**Memorandum No: 25-054**

**SUBJECT: New Police Headquarters — Phase 2 Peer Review**

This memorandum is being sent to update the City Commission on the Phase 2 peer review being conducted by Wiss, Janey, Elstner Associates, Inc. (WJE) related to certain portions of the Fort Lauderdale Police Department Headquarters (PDHQ).

On April 22, 2025, WJE provided the City with a draft Phase 2 peer review. This review analyzes the remaining portions of the building for structural deficiencies, provides code references in support of the findings, and makes conceptual recommendations for addressing these issues.

Figure 2. Plan view of the foundation level of the FLPHQ from Sheet HQ-S2-2-01 (dated June 10, 2022) of the structural design drawings with gridlines and shear wall locations shown. Annotations in blue by WJE

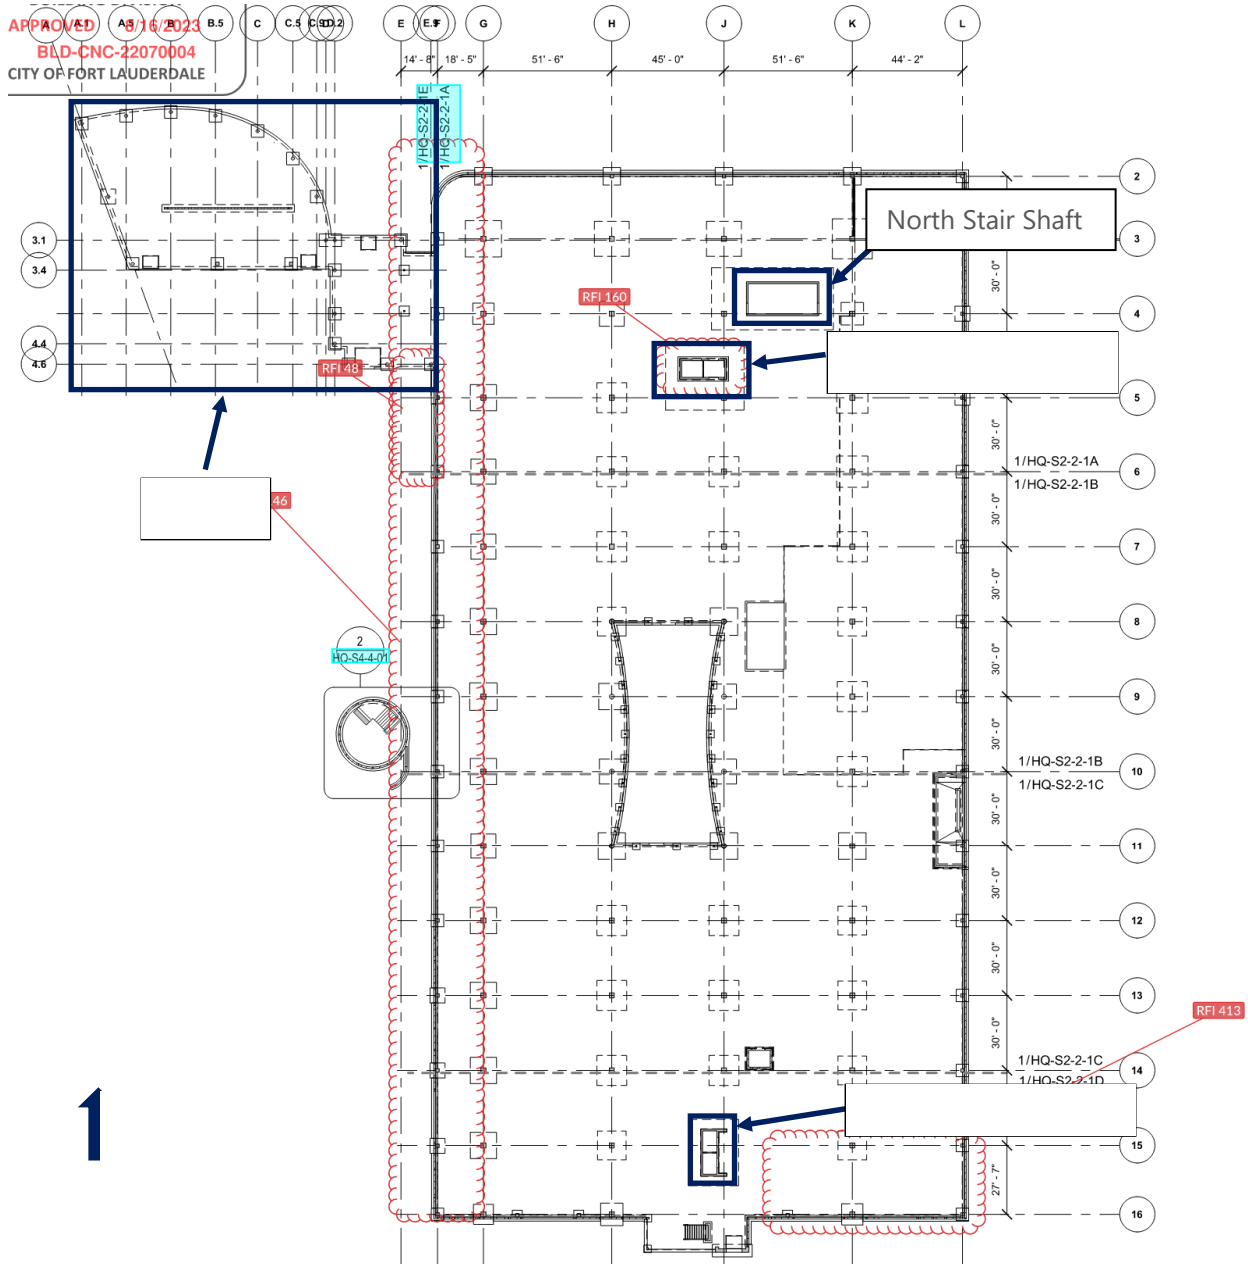
The lateral force-resisting system for the building is composed of cast-in-place reinforced concrete shear walls. See Figure 2 for the locations (on plan) of these walls.

Figure 3. Image from the file "2025311\_FLP Column H-2 and J-2 Validation.pdf" (dated March 11, 2025) prepared by the SEOR which indicates that they used a flexural stiffness modifier of 0.35 for reinforced concrete columns along Gridline 2

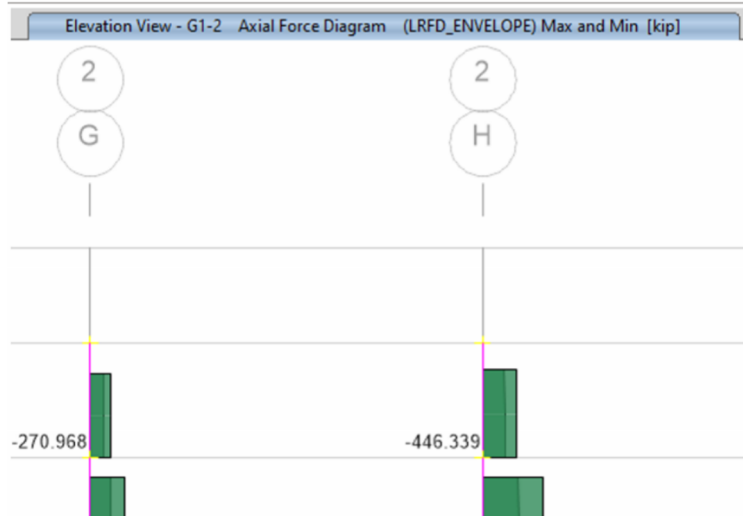
- 16. Column Flexural Stiffness Modifiers.** The documents we received from the SEOR indicate that a wide range of column flexural stiffness modifiers were used in the design of the FLPHQ, ranging from assuming pin-ended behavior (i.e., effectively a modifier of 0.00) to using a modifier of 0.70. We concur that in the design of a building, it may be prudent to use different modifiers when designing (e.g.,) the gravity- and lateral-load resisting system. For example, ACI 318-14 Section 6.6.3.1.1 recommends using a flexural stiffness modifier of 0.70, but Section 6.6.3.1.2 allows a modifier of 0.50 to be used when considering lateral loads, thereby conservatively decreasing the lateral loads resisted by the columns and increasing those used to design the shear walls. However, the SEOR appears to be using at least three different stiffness modifiers (0.00, 0.35, and 0.70), whichever is most favorable to their position, regardless of whether or not it is legitimate or reasonably supported by code provisions. In fact, the SEOR’s use of modifiers to obtain favorable results seems to be contrary to the intent of ACI 318-14. We recommend that the SEOR carefully review the impact of column stiffness modifiers to determine if their understanding of member demands is within accepted engineering practice. Supporting documentation (code language, research papers, etc.) should be provided to substantiate the use of stiffness modifiers which are contrary to code provisions. If the SEOR accepts the recommendations made by WJE in Items 1 through 7 above, it is not necessary to respond to this item and no further changes are expected.

Figure 4. Detail 7 from Sheet HQ-S7-1-02 which shows CMU wall bearing on thickened slab-on-ground. Note that there is a vapor retarder under the slab-on-ground supporting the partition masonry walls

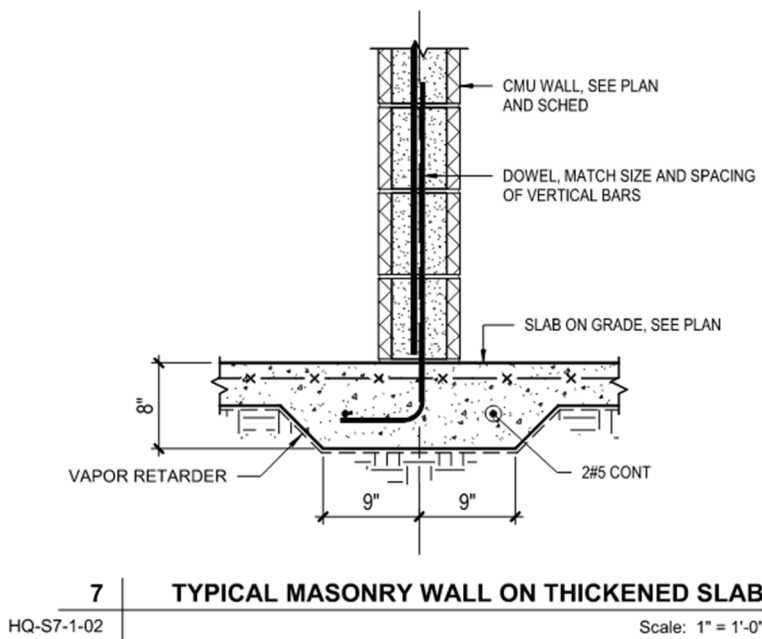
On numerous sheets in the structural drawings (e.g., Sheet HQ-S2-2-1A), the CMU partition walls are referred to as “non-loadbearing CMU” which bear on thickened slab built over a vapor retarder (Detail 7 of Sheet HQ-S7-1-02). A vapor retarder would reduce the sliding resistance of the wall.

**Masonry Wall Connection Details at Top and Bottom of Wall.** Both 7/HQ-S7-1-02 (Figure 4) and 2/HQ-S6-1-01 (Figure 5) indicate that the vertical reinforcement at the bottom of the CMU walls should be lapped with dowels. These dowels were to extend into the footing, or thickened slab, and be hooked. At the top of the CMU walls, two details are provided on Sheet HQ-S7-1-02, which is labeled as “Typical Masonry Details”. Detail 3/HQ-S7-1-02 appears to be a detail for use with CMU walls that are bearing walls. A note in this detail also indicates that this detail applies when tie-beams are referenced on plan. We did not observe any tie beam references on plan, and we also did not observe on the plans where any CMU walls were explicitly designated as bearing walls. As such, Detail 3/HQ-S7-1-02 appears to not be applicable to the interior masonry walls. A wall schedule shown on HQ-S6-1-01 (see Figure 6) also does not explicitly designate any of the CMU walls as bearing walls. The masonry shaft noted above would necessarily be a bearing wall as it supports the end of concrete joists, but all other walls (not within Area E) appear to be non-loadbearing walls and in fact are believed to have been constructed as infill after the concrete structure was built.

**Report No. 087, Dated January 8, 2024:** The TI notes that “SOG pour 4 rebar. Dowels for CMU wall need to be rearranged [sic] so that the compy [sic] with detail 7/HQ-S7-1-02 for typical masonry wall on thickened slab.” The TI also notes: “On CMU wall on lvl 1 area A grid line 4, rebar needs to be extended to the bottom of lvl 2 slab. See image on next page.” See photographs from the report in Figure 19.

**Report No. 107, Dated February 8, 2024:** The TI notes that “Partial inspection of slab rebar for SOG pour 5. Dowels for CMU need to be lowered to comply with what is specified on detail 7/HQ-S7-1-02.” Figure 24 shows a photograph of this condition and a photograph of a CMU wall under construction. Again, note that no shoring of the structure above is present, indicating that the CMU wall was not constructed as a bearing wall.

Figure 5. Detail 2 from Sheet HQ-S6-1-03 which shows CMU wall foundation for wall footings that have WF# designation on the foundation plans. Note that the vapor retarder under the slab-on-ground does not pass under the wall footing

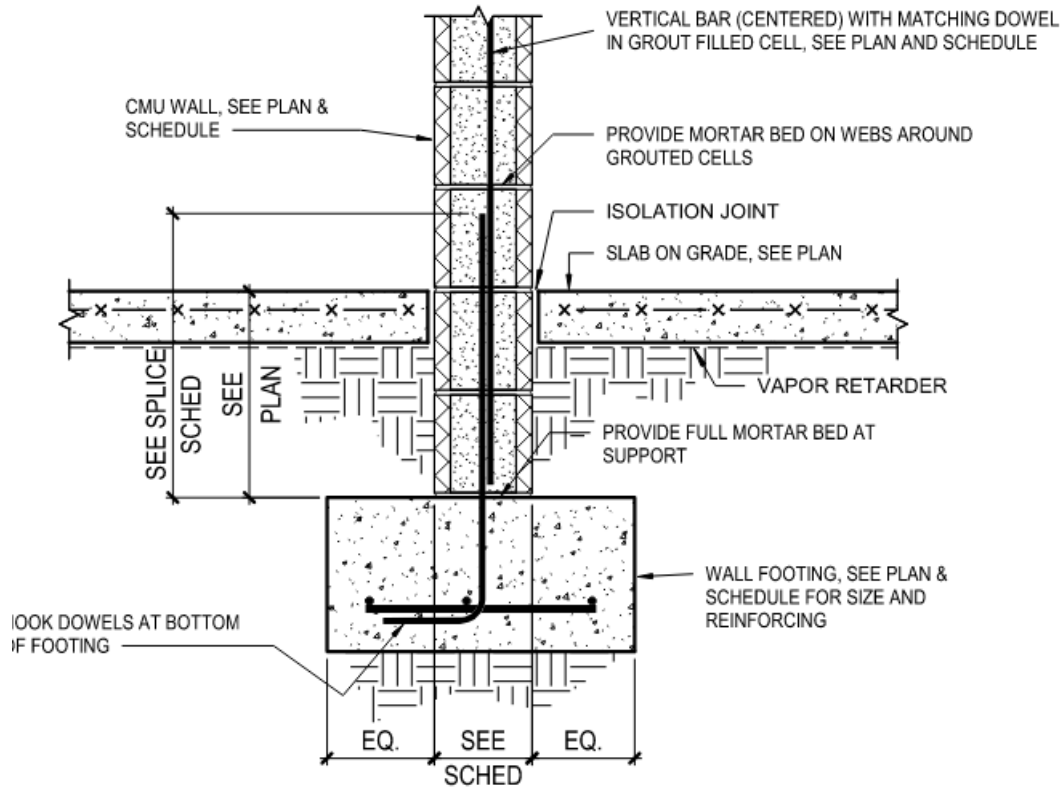
Furthermore, it is evident that the SEOR is aware of what good practices are for designing masonry shear walls, evidenced by the east-to-west spanning wall used in Area E. Unlike the partition masonry walls, that wall a) was constructed such that axial and diaphragm loads from the roof can be transferred to the wall (Figure 23), b) has vertical reinforcement that is well-anchored to develop shear-friction resistance (Figure 11), and c) has a standalone wall footing without a vapor retarder underneath it, thereby increasing the sliding resistance of the wall (Figure 5).

Figure 7. Detail 6 of Sheet HQ-S7-1-02 which shows two options for connecting the partition CMU walls to the elevated slabs or beams

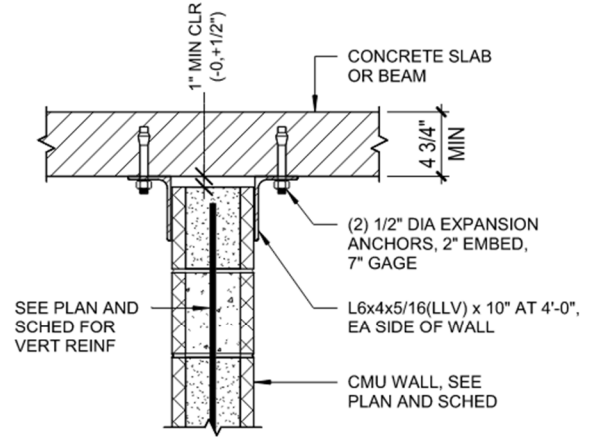
None of the connections of the partition masonry walls (i.e., not including the bearing wall in the community room and the masonry core wall in the main structure) to the diaphragm shown in the structural drawings (Detail 6 of Sheet HQ-S7-1-02) or noted in the special inspection reports (i.e., PTA anchors) satisfy ACI 318-14 Section 12.5.3.7. In other words, these connections do not satisfy the shear-friction provisions of ACI 318, which invalidates the masonry walls as code-compliant contributors to lateral resistance.

Furthermore, the alternate option provided in Detail 6 of Sheet HQ-S7-1-02 shows a minimum gap of 1 inch between the top of the walls and the bottom of the above floor. Should this detail have been used, the walls would only start resisting floor loading once (or if) the gap closed, clearly indicating that the SEOR did not originally intend for the walls to carry axial loading from the above floor. In their recent lateral system calculations package (dated almost three years after issuance of the permitted structural drawings), the SEOR indicated that axial load in the walls was requisite to develop the sliding resistance of the so-called “CMU shear walls.” It is confounding that the SEOR would propose using a connection detail that effectively precludes axial load from entering the wall (apart from self-weight) if their design relied on sliding resistance, unless of course, the original design did not intend for those walls to be a part of the lateral system of the structure.

Detail 6/HQ-S7-1-02 (Figure 7) is further divided into two details, a typical detail that applies to both interior and exterior walls and an alternate option that applies to interior walls only. The typical detail shows the vertical reinforcement of the CMU wall embedded into the slab above. No minimum embedment depth is provided, but the details note that the slab thickness must be a minimum of 4 ¾ inches. Section 042200 of the specifications, “Concrete Masonry Units” Part 2.6.C addresses “Top of Wall Anchors.” This specification section is shown in Figure 8. Interior non-load bearing partition walls in Seismic Design Category A, which applies to the FLPHQ, are shown to allow PTA series anchors by either Blok-Lok or by Hohmann & Barnard (H&B). A specification sheet for PTA 420 HS anchors by H&B is shown in Figure 9. A lateral load capacity for the anchor is not provided on this sheet nor is the type of fastener (e.g., screws) required to connect the anchor to the concrete structure above. It may be that this information exists somewhere else on H&B’s website, but we could not find it. As such, it is unclear to us if these anchors are approved or rated for lateral load transfer, and if so, what load they are rated for. Also unclear is the capacity that the SEOR assumed for these anchors. A rendering of the PTA 420 HS anchor at the top of a CMU wall (also taken from H&B’s website) is shown in Figure 10. Note that the anchor is shown with the length of the top plate oriented transverse to the length of the wall, suggesting that its rated capacity would be applicable to out-of-plane rather than in-plane loading.

**Diaphragm Shear Transfer.** The lateral load calculations package does not address whether the connections between the concrete floor diaphragm and masonry walls are adequate to transfer shear from the diaphragm. Detail 6 of Sheet HQ-S7-1-02 (Figure 7) of the structural drawings indicate two details for connecting the masonry walls to the slab or soffit beams. The first option (the “typical detail”) entails embedding the vertical wall reinforcement several inches into the diaphragm. Lateral load from the diaphragm might thereby be presumed to be transferred into the CMU walls through shear friction. However, Section 22.9.5.1 of ACI 318-14 requires that shear-friction reinforcement be developed on both sides of the friction interface, which the reinforcement in the wall is not, since per Section 25.4.2.1, the bars must be embedded at least 12 inches to develop the bar, which they are not. Therefore, this detail

does not comply with the ACI 318-14 code if its intent is to transfer diaphragm shear through shear friction. The second option shown in Detail 6 (the “alt. option”) entails anchoring two angles into the diaphragm on either side of the wall, presumably to laterally brace it. Since the angles are not anchored into the wall in the detail, lateral load from the diaphragm cannot be transferred into the walls. Moreover, a gap with a minimum thickness of 1 inch is shown between the top of wall and bottom of diaphragm, the intent of which appears to have been to preclude the wall from receiving diaphragm shear and floor gravity loading until the gap closes. Additionally, various threshold inspection reports (e.g., No. 123) show PTA 420 HS anchors (produced by Hohmann & Barnard, Inc.) which are post-installed into the soffit beams and slabs using Tapcon screws and tied to the vertical reinforcement from the CMU walls (Figure 17, Figure 20, Figure 26, and Figure 27). This connection cannot reasonably transfer diaphragm shear into the walls either. Threshold inspection report No. 80 notes “CMU walls to be braced to the soffit beams using PTA 420 HS anchors as per approved summittal [sic] #0422000-13.0 instead of detail 6/HQ-S7-1-02,” suggesting that these anchors were used for most connections of CMU walls to soffit beams. For these reasons, we recommend that the SEOR provide calculations for review demonstrating that the wall-to-diaphragm interface connections are adequate to transfer shear from the slabs into the walls.

Figure 12. Section through joint between Area E and the main building of the FLPHQ showing the lower beam from Area A the stub column above, and the upper beam from the main building of the FLPHQ. The slide bearing is located at the top of the stub column

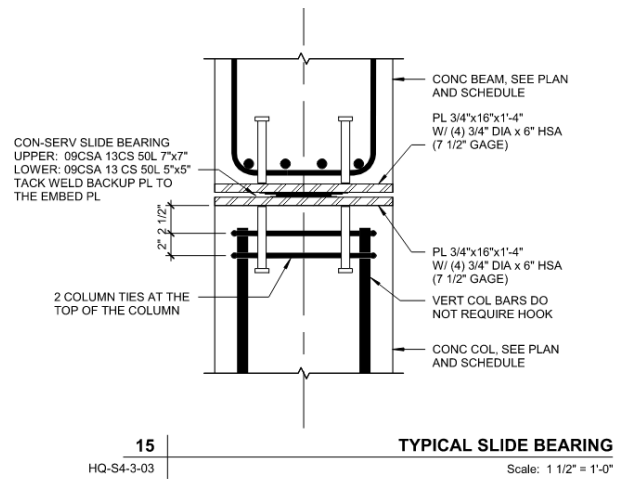
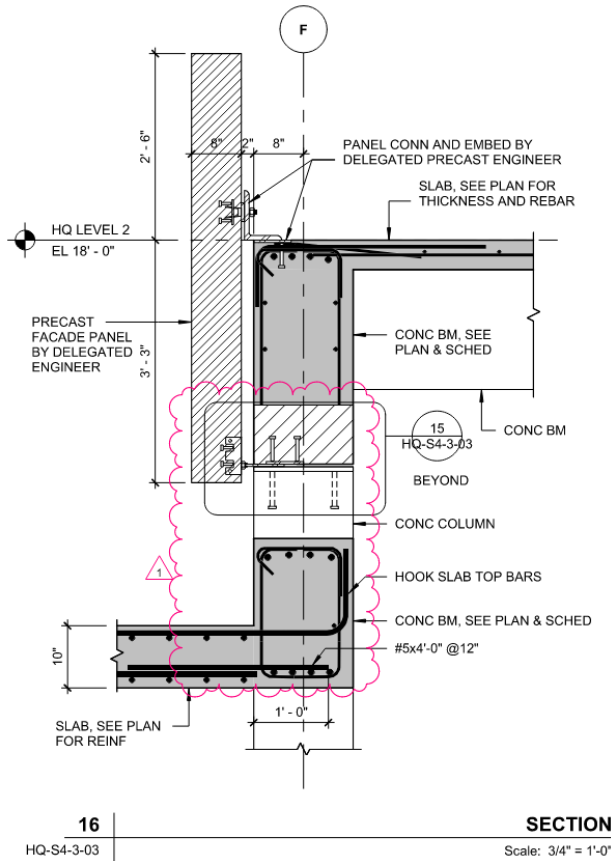
**Slide Bearings.** The SEOR has incorporated slide bearings into their design at the joint between Area E and the main portion of the building. These slide bearings are intended to allow the two buildings to move somewhat independently under lateral and thermal loading while transferring gravity loads across the joint. These slide bearings apply to columns at Grid Points F/3 and F/4. Figure 12 shows a section of the lower beam from Area E, a stub column extending up to the slide bearing, and the upper spandrel beam from the main building above the slide bearing. Figure 13 shows the detail for the slide bearing and calls out the specific slide bearing to be used, which is Con-Serv CSA slide bearing. Con-Serv’s website indicates that the CSA bearings have an allowable bearing pressure of 2,000 pounds per square inch (psi) and also indicates that the total capacity of the bearing is based on the area of the lower portion of the bearing. Since the area of the lower portion of the bearing is 25 square inches (5 inches times 5 inches) in the design (see Figure 13), the allowable bearing capacity of the slide bearing is 50,000 pounds or 50 kips. Con-Serv’s website also indicates that the allowable bearing capacity reduces with temperatures increasing above 70 degrees Fahrenheit, as shown in Figure 14. Con-Serv also provides the sliding friction coefficient as a function of load (Figure 15). The results of capacity checks of these slide bearings are provided later in this report, along with checks of structural members.

The beams above the bearings may be lifted or “jacked” slightly to permit removal of the existing bearings. Care should be taken not to damage the surrounding elements while lifting the beams. If the beam cannot be lifted without damage to surrounding elements, then the beams can be supported on shoring, the near-surface layer of concrete can be removed from the stub columns, and the embedded plate (shown on Detail 15 of Sheet HQ-S4-3-03) can be removed to enable removal of the pads. The stub column should then be repaired before replacing the slide bearings and removing the shoring.

Figure 17. Photographs from Threshold Inspection Report No. 081. Left photograph shows overall wall construction on first story at one location. Right photograph shows the PTA anchors at the top of the wall. Note that two screws are used to connect each anchor to the above element

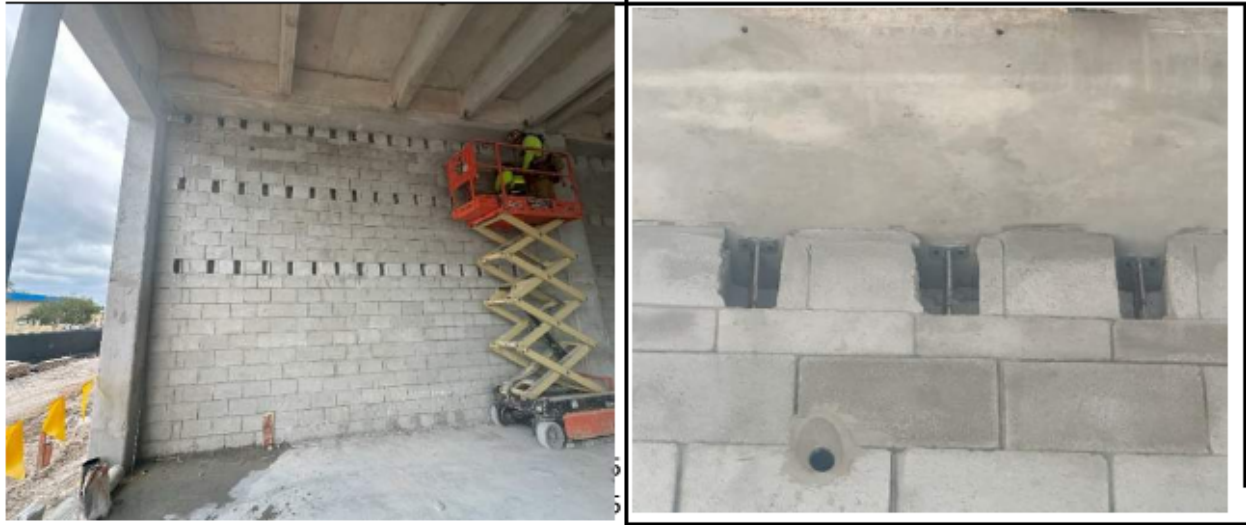
**Report No. 081, Dated December 19, 2023:** Comments by the TI are in regard to the concrete used in slab-on-ground Pour 3. However, photographs of CMU walls in the first story are also shown in the report (Figure 17). These photographs show the overall CMU wall construction at one location in the first story and the approved PTA anchors at the top of the wall. The length of plate at the top of the PTA anchors is aligned parallel with the length of the CMU wall in contrast with the rendering shown on the manufacturer’s website (Figure 10).

Figure 18. Photographs from Threshold Inspection Report No. 084. Upper photographs and lower right photograph appear to be of the first story prior to full installation of CMU walls. Note the lack of shoring indicating that the CMU walls were not constructed as bearing walls

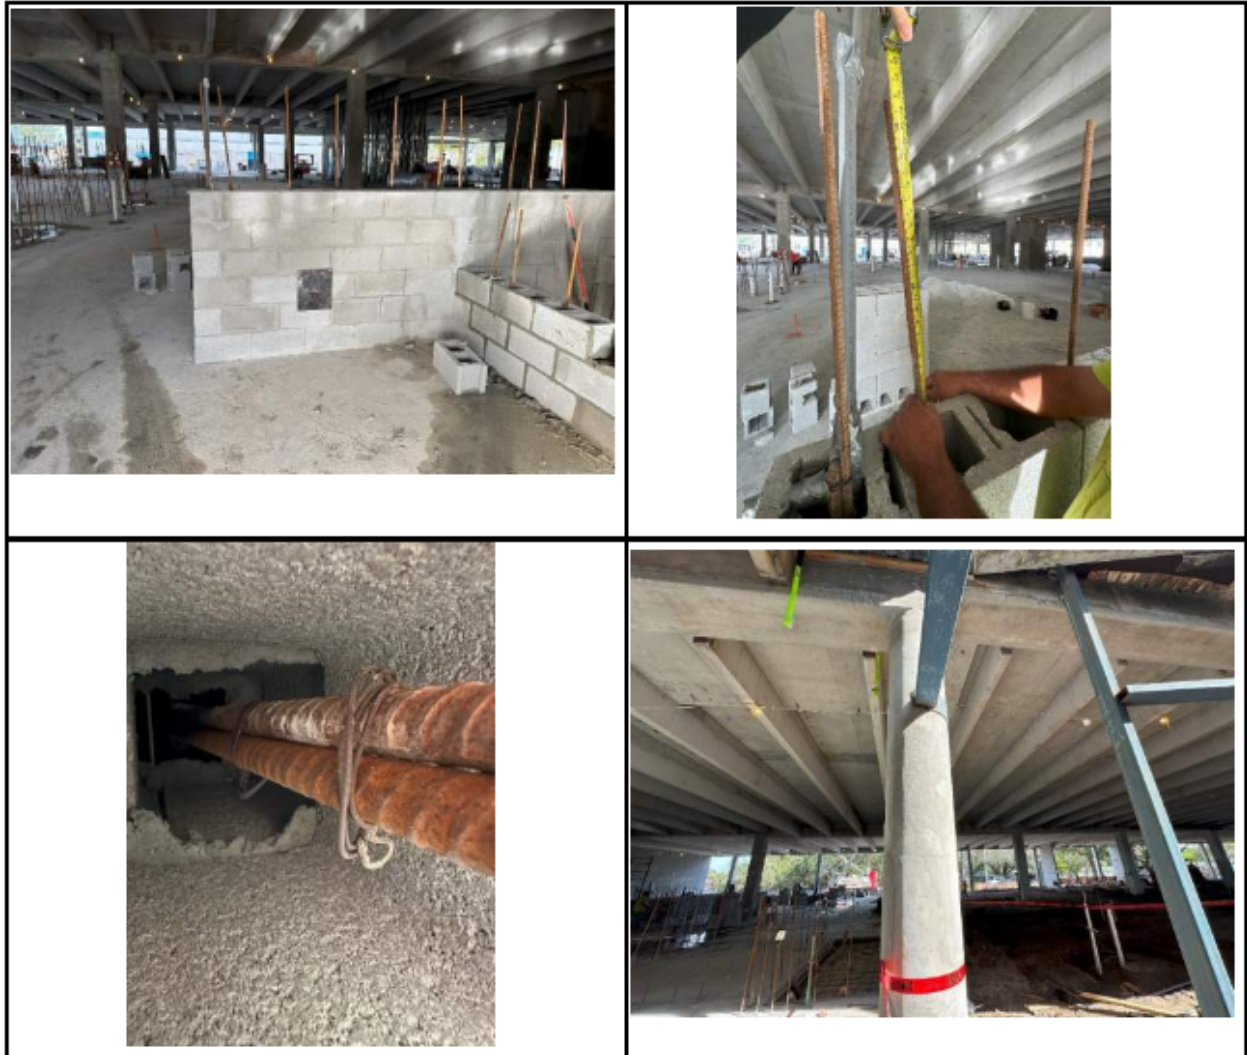
**Report No. 084, Dated January 2, 2024:** The contents of this report are not in regard to CMU wall construction, but the included photographs (Figure 18) appear to show the first story with vertical reinforcement extending upward from the slab-on-ground, but prior to the CMU walls being fully installed. No shoring of the structure above is present, indicating that the CMU walls were not constructed as bearing walls.
